# Intel<sup>®</sup> 82371AB PIIX4, Intel<sup>®</sup> 82371EB PIIX4E, Intel<sup>®</sup> 82371MB PIIX4M

## Specification Update

*January 2002*

Document Number: [297738-017](#)

##### QUEUE HEAD LINK POINTER (DWORD 0: 00-03h)

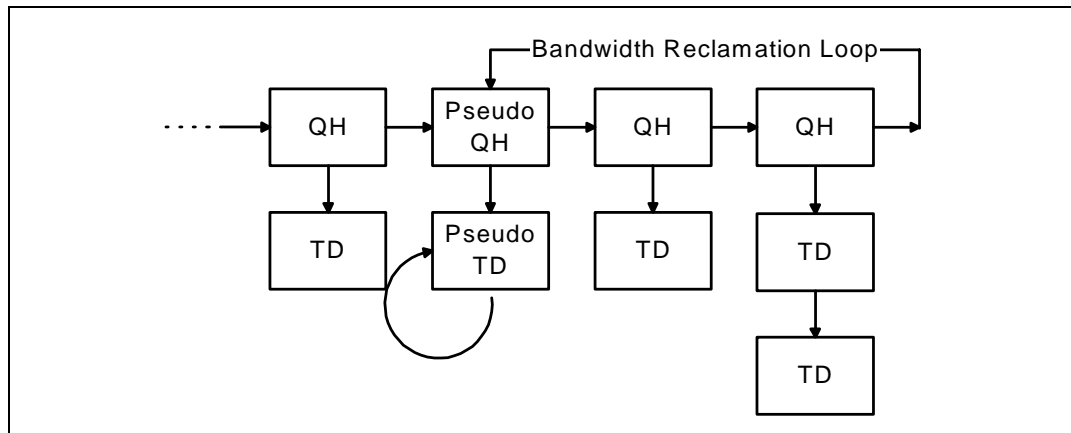
The Active status bit (bit 23) must be left unset at 0 indicating that the PIIX4/PIIX4E/PIIX4M should not execute this TD.

The Queue Head Link Pointer (QHLP=bits [31:4]) must be set to point to the pseudo TD.

The QH/TD Select (Q=bit 1) must be set to 1 indicating it is a QH.
